# Feedback of 2025 IDRC Review Report

中國科學院高能物理研究所  
*Institute of High Energy Physics*  
*Chinese Academy of Sciences*

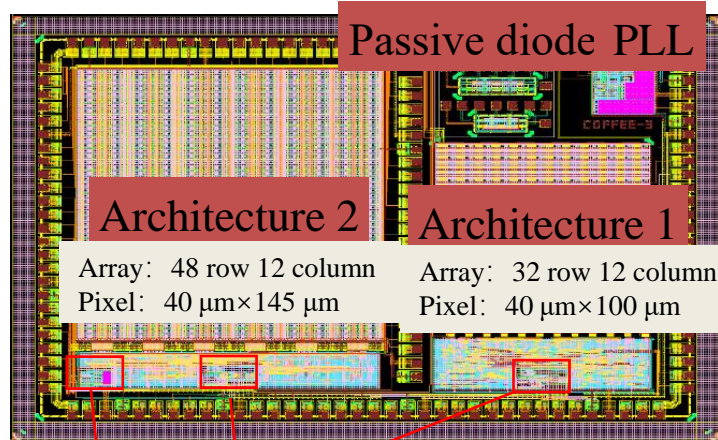
- We strongly encourage prioritizing the COFFEE3 validation campaign. As a comprehensive integration of position sensing and timing capabilities within a monolithic HV-CMOS technology, successful testing of COFFEE3 would constitute a critical milestone for the CEPC silicon tracking system, helping to de-risk the ITK concept and validate the soundness of the baseline detector design.

The latest COFFEE3 sensor was received at the end of May, and the sensor test campaign was launched immediately upon receipt. The test setup is fully prepared, and testing is currently underway. We are committed to completing the critical validation promptly, as it represents one of the most important milestones for the ITK.

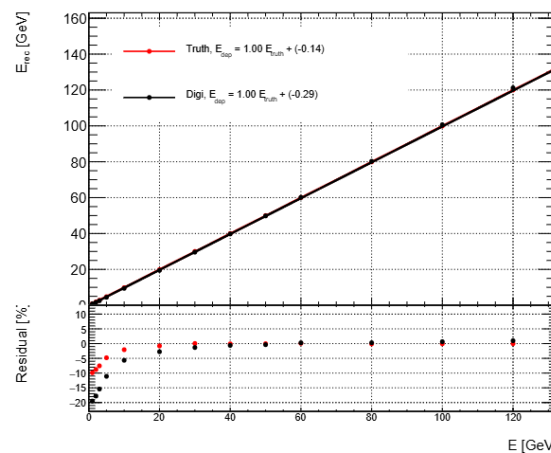
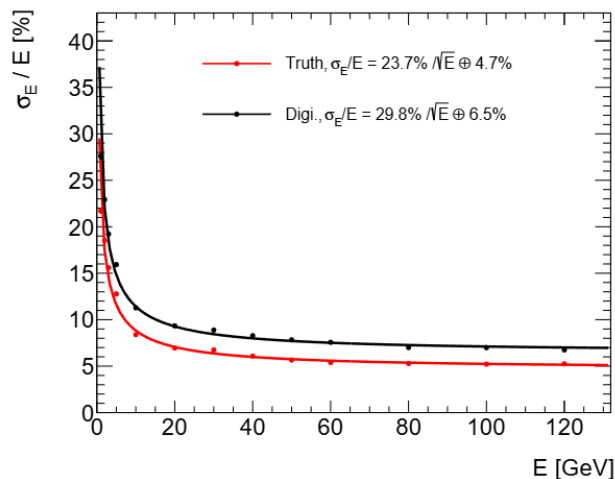
- IDRC comment: lack of justifications or motivations for the timing resolution specified (0.5 ns per end)

- To investigate potentials of ECAL timing in mitigation of Beam-Induced Background effects, especially excessively high hit rates in certain regions (e.g. barrel ECAL inner layers, endcap modules close to the beam pipe)

- This timing study would be complementary to the BIB mitigation scheme by increasing energy thresholds for certain ECAL layers (0.1 MIP  $\rightarrow$  0.2 or 0.3 MIP )
  - Balance between EM performance and BIB hit rates

Figure 1.45: MIP response spectra of (a) #1 glass wrapped with Teflon tested by 10 GeV muon beam at CERN, (b) Quasi-MIP response spectrum for #4 glass scintillator tile tested by 5 GeV electron beam at DESY.

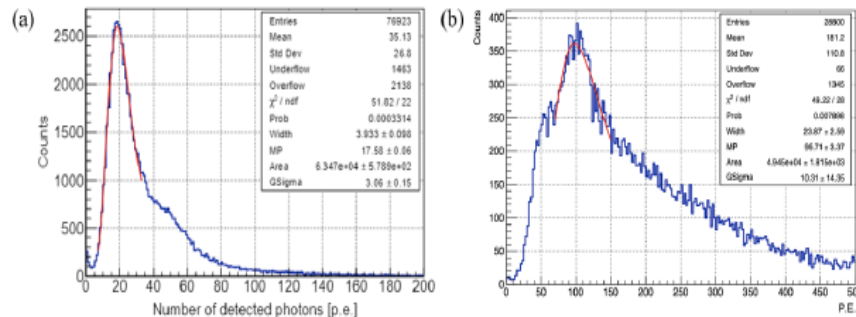
- The authors are encouraged to make the text more concise where possible, while still providing sufficient detail where necessary.
  - In Fig. 8.45, while the test beam setup is now described, the reason for the visible shoulder (likely due to a double MIP peak) is not explained. Since the test beam is a major highlight of the R&D effort, the authors should focus on presenting it clearly and concisely, possibly selecting a few key highlights for emphasis.

- this part was rewritten as 8.4.2 Glass Scintillator --> Light Yield --> the MIP response. Also the figure was changed as the new one **Figure 8.8**.

Figure 8.13: Measured ADC spectrum of GS cell with a SiPM (HPK S14160-3050HS) using  $^{137}\text{Cs}$  radiative source.

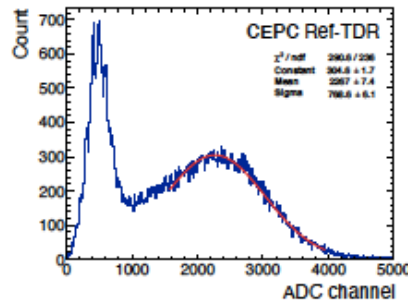
In the draft we don't see the results of all the (few) tiles that have been e.g. tested beam or in the cosmic stand

--In Fact, in the Section 8.4.5 Measurements of GS with SiPM, the Figure 8.13: Measured ADC spectrum of GS cell with a SiPM (HPK S14160-3050HS) using  $^{137}\text{Cs}$  radiative source. Figure 8.14: Cosmic ray test results of the GS tile measured using SiPMs.
